January 28, 2005

RE: Bear River Casino –Project Review/ Off-site Impacts

FIGURE 1

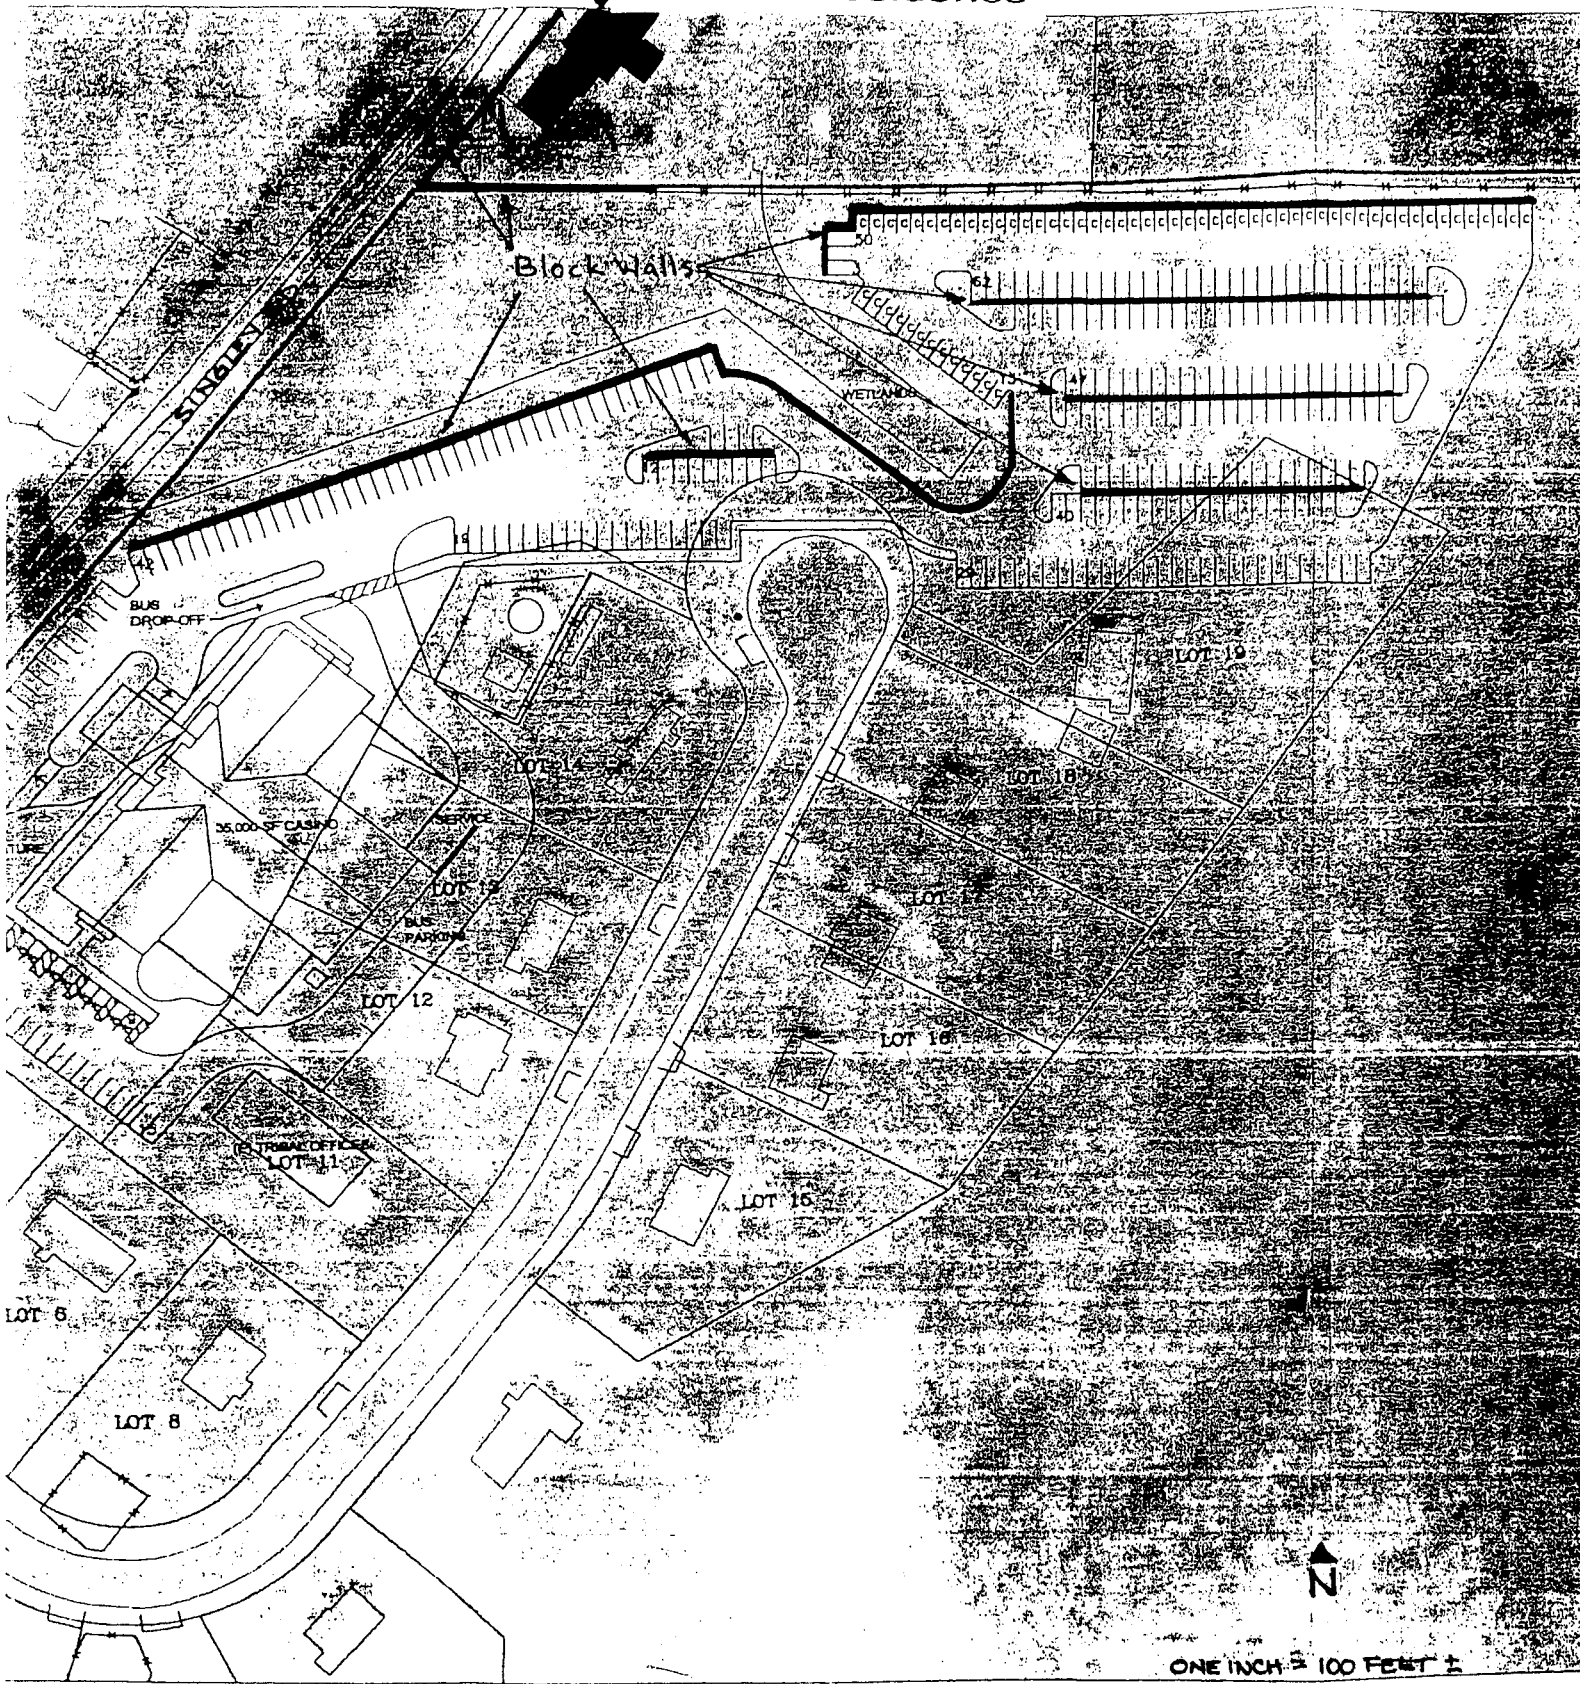
Other than construction noise the document provides no background or analysis to reach the stated conclusions. Your residence is approximately 20 feet from Singley Road, 120 feet from adjacent parking areas and 325 feet from the casino facility itself. The Casino's secondary access into the building is closest to your residence and is designated as the bus drop off point. It is also designated as the future expansion area, bringing activities even closer to your residence. Since the majority of the parking is on this side the secondary building entrance may get the majority of use at peak times. Your residence is close in elevation to this activity, making it more susceptible to the increase in noise.

Parking lot traffic related noise levels of 66-68 dBA would be reduced by approximately 8 decibels where you have line of sight based on distance alone (Table 1). The existing vegetation at your residence may reduce these levels by an additional 3 dBA's. Parking lot levels would be estimated to be 57 dBA at your residence. By adding four hours of night time activity (10:00 p.m. to 2:00 a.m.) this would increase to a 60 dBA Ldn level. Since 80% of the parking is near to your residence several decibels should be added to the already high levels at the exterior of your residence from Singley Road traffic resulting in an approximate exterior level of 70-72 dBA Ldn.

1. The most effective mitigation would be construction of a block wall along the northern perimeter of the parking area north of the casino. Due to the slope of the parking area the block wall would have to be at a height that blocks the line of sight to your residence. Therefore the spaces north and east of the existing cul-de-sac would result in a higher wall requirement. As an alternative to a very high wall along the perimeter, a shorter wall (6') could be utilized with 4 foot high walls between rows of spaces (See Figure 1). This would achieve the added mitigation of reducing headlight beams into your windows.(discussed under "Visual Resources").

1. Again the most effective measure would be construction of a solid block wall the full frontage of your property. You already have a two foot high wall in front of your residence. A minimum four foot wall might suffice but due to the elevational differences this wall may need to wrap partially along your side property lines to eliminate line of sight traffic noise sources (as well as headlight beams, as discussed under "Visual Resources"). Since you mentioned cedar plank or slatted chain link alternatives, neither of these would be effective at reducing noise created by traffic. Cedar plank would also have high maintenance needs and be subject to blow down from winds.
2. Replacement of all single pane windows at your residence with sound insulated window panes. This will be necessary to reduce the interior noise levels an additional 5 dBA.
